Insights concerning "Supply lines for additional TPRDs"

Proposal for the 03 series of Amendments to UN R134 from Japan

New insights concerning "Supply lines for additional TPRDs" for GTR13

Proposal for an Amendment to GTR13 from Japan

Cylinder Assembly – Type 3

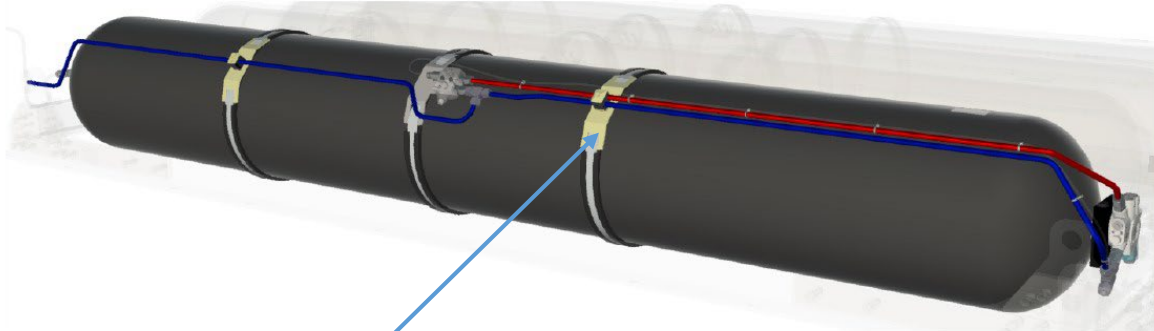
Supply and Vent lines cannot be too rigid due to cylinder expansion

This parts is considered that provide additional support and/or protection to the supply lines for additional TPRDs.

In the current proposal, this parts is not included in the definition of CHSS but may be used for each test such as Verification tests for performance durability. It is necessary to consider whether this parts should also be defined together with supply lines for additional TPRDs or not.

Regarding the parts, as we consider them to have the same functionality as a container attachment. [1]

Additionally, we are concerned that attaching the parts to the container may cause severe abrasion to the composite surface like as mounting straps. [2]

Therefore, we propose adding the following footnote to the draft definition of "Container Attachment" [1] and amending "Surface damage test" in Annex 3, Paragraph 3.3.(a) as follows [2]:

[1] "2.5. "Container Attachments" mean non-pressure bearing parts attached to the container that provide additional support and/or protection to the container and that may be only temporarily removed for maintenance and/or inspection only with the use of tools.

Note : The non-pressure bearing parts attached to the container that provide additional support and/or protection to additional TPRDs and supply lines are also considered as container attachments. "

[2] 3.3. Surface damage test (unpressurized):

"(a) Surface flaw generation: A saw cut at least 0.75mm deep and 200mm long is made on the surface specified above.

If the container is to be affixed to the vehicle by compressing its composite surface **or container attachments for additional TPRDs and/or supply lines are attached to composite surface of the container**, then a second cut at least 1.25 mm deep and 25 mm long is applied at the end of the container which is opposite to the location of the first cut;"
